C2032x MAIN FIRMWARE RELEASE NOTES

Uni-7 Series with PK-260B CPU Board

C2032x supersedes B0779x as the standard Uni-7 firmware for the revised PK-260B CPU board.

C2032x PK-260B with SD Memory Card Slot

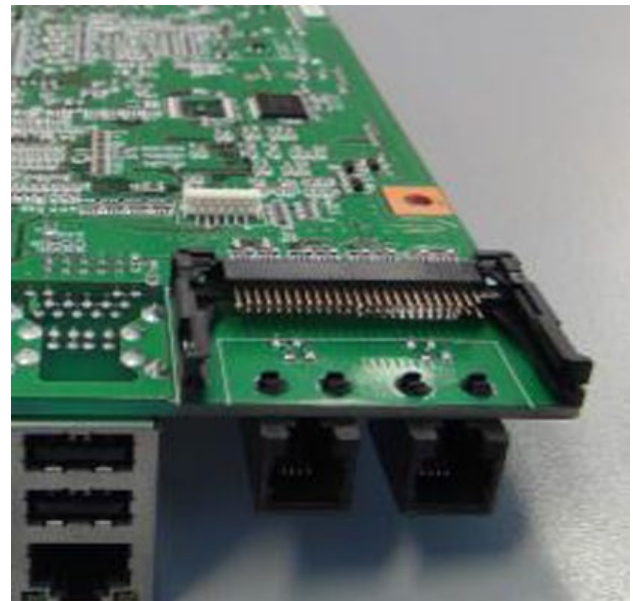
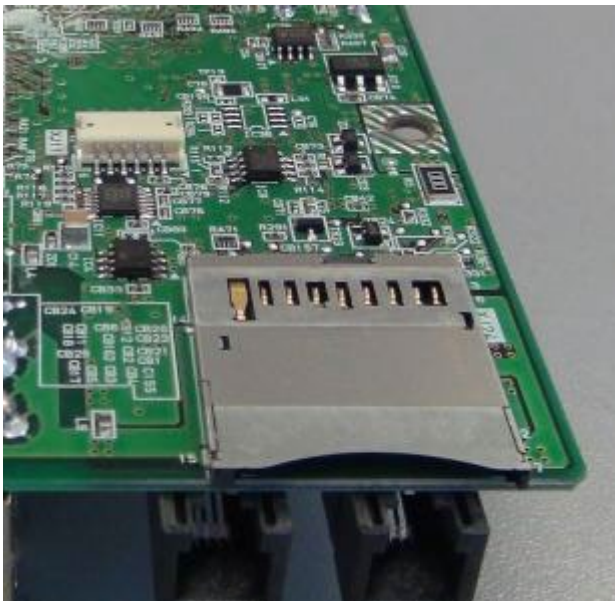
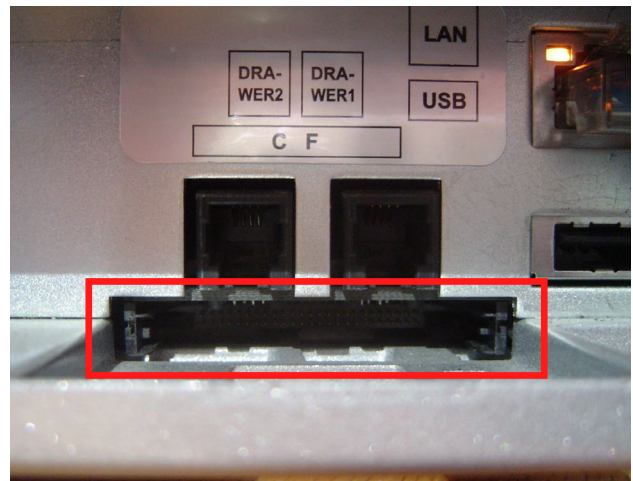
Firmware C2032x is designed for the revised CPU board PK-260B. **This firmware is not compatible with the previous CPU board PK-260A.** And previous firmware (B0674x, C1991x, etc.) is not compatible with the new PK-260B CPU board.

The two CPU board versions can be easily identified by the expansion memory card slot located on the left side of the Uni-7. See the images below.

SLP-V Total Price +10%

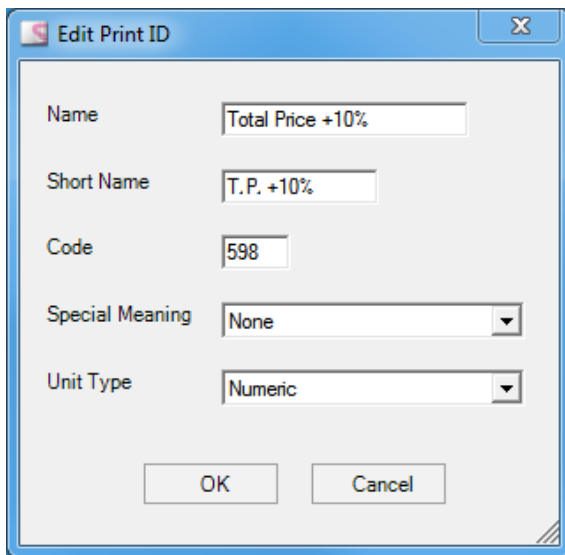
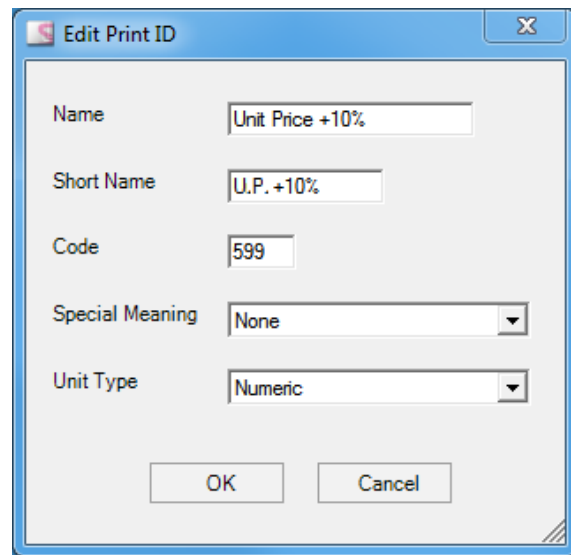
- 2. Added two Print ID fields:
 - a. 256 (598 in SLP-5): +10% Total Price
 - b. 257 (599 in SLP-5): +10% Unit Price (calculated from dividing +10% Total Price by weight)

- 3. SLP-V and SLP-5 must be updated to support the two new Print ID fields. The new Print IDs are added as follows:
 - a. Open SLP-V or SLP-5 Setup Utility program.
